**MEMORANDUM**

DATE: March 9, 2012

SUBJECT: BZA 18313: 1328 14th Street, NW

**HISTORIC PRESERVATION REVIEW BOARD
STAFF REPORT AND RECOMMENDATION**

OFF STREET PARKING, COMPACT SPACES AND LOADING

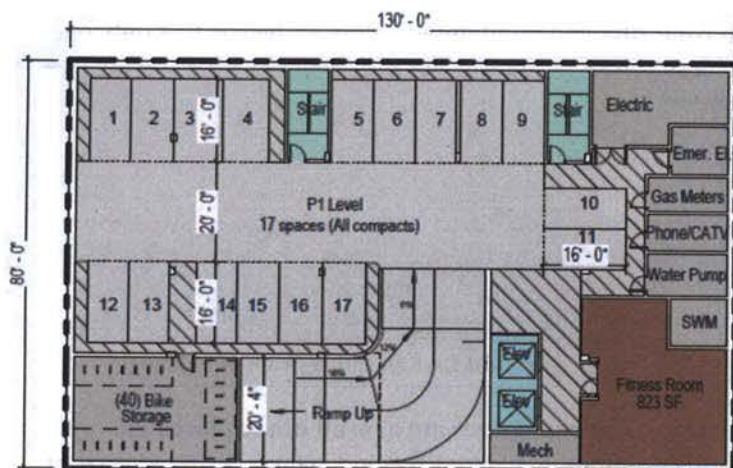
The property is subject to a combination of factors which makes it unique and creates a practical difficulty for the applicant. The subdivided property is long and narrow, 80 feet width and abuts a narrow 10-foot wide alley at its rear. These site constraints directly impact the ability of the site to accommodate the required number and size of the off-street parking spaces, as well as the required number of loading berths and platforms.

Twenty-seven spaces would be required to satisfy the residential requirement and four spaces would be required to support the proposed ground floor retail. The proposal assigns no parking to the retail and would have 20 spaces dedicated to residential use, 17 of which would be on one level below grade. The lot's size creates a practical difficulty for the provision of the required number of parking spaces, since the required ramp widths at 14 feet (minimum) and associated ramp turns would require more space than the lot width would reasonably accommodate in order to provide a meaningful number of spaces at an additional level below grade. More importantly, the required ramp slopes to grades below the first level would require a grade of more than 12% (§2117.8 (a)), and would require variance relief, if engineering standards determined that a steeper grade would be safe.

The applicant proposes to provide 85% of the required parking as compact spaces (17 spaces) where only a maximum of 40% is permitted (§ 2115.2). Again, the lot's narrow width adversely impacts this requirement as the required drive aisle, ramp width and the building's required support structures, including the bike storage area, stairwells and elevator cores would consume the majority of the below grade space, thereby reducing the area that would be normally devoted to regularly sized 9' x 19' parking spaces. Thus, in order to effectively meet the on-site parking needs of future residents compact spaces would be provided for all spaces proposed below grade.

Residential buildings with more than 50 units require a 55-foot deep loading berth, a 200 square foot loading platform and a 20-foot deep service delivery platform. The 4,135 square-foot retail area would not generate a loading requirement, as it is less than 5,000 square feet (§2201.1). As supported by the applicant's submitted diagram on T01, the alley width and the lot's size combine to create a practical difficulty in that a 55-foot

would not be able to enter the 10-foot wide alley. Further a 55-foot loading berth would be underutilized and would unnecessarily consume valuable residential and retail square footage and adversely impact the building's configuration. The applicant has the right to use an existing 10-foot wide easement which would effectively widen the alley in the immediate area of the building and accommodate the turn movement for trucks. However, this too would not be sufficient to support greater turning radii for larger trucks. Therefore, given these parameters, the lot width could only reasonably support a 100 square-foot platform and a 30-foot deep loading berth.

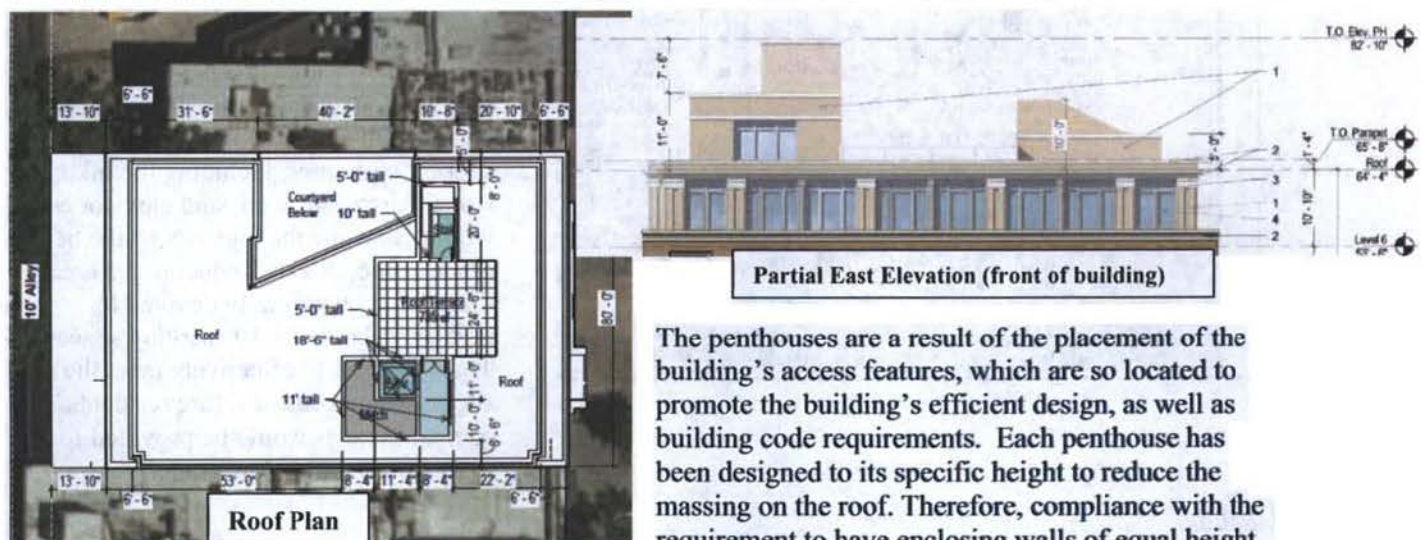
None of the variances requested would significantly impact the public good and none would impact privacy, light and air to abutting properties. The proposed reduction in the residential parking supply would be off-set by the applicant's provision of bike storage well in excess of the required in support of alternative transportation modes. 14th Street is a major transportation corridor, which supports many cross-town Metrobus routes, as well as a Circulator bus route. Therefore, a substantial increase in on-street parking by residents is not anticipated as a result of the reduced off-street parking supply. Similarly, the reduced loading is adequate to support the residential use, as the sizes of the residential units are not anticipated to accommodate excessive furniture. Therefore, large delivery or moving trucks would not be expected to be hired at move-in or out. The applicant has not stated whether the units would be leased or purchased which would have an effect on the frequency of use of the loading area. OP expects the use and times for the loading area would be regulated by the property's management.
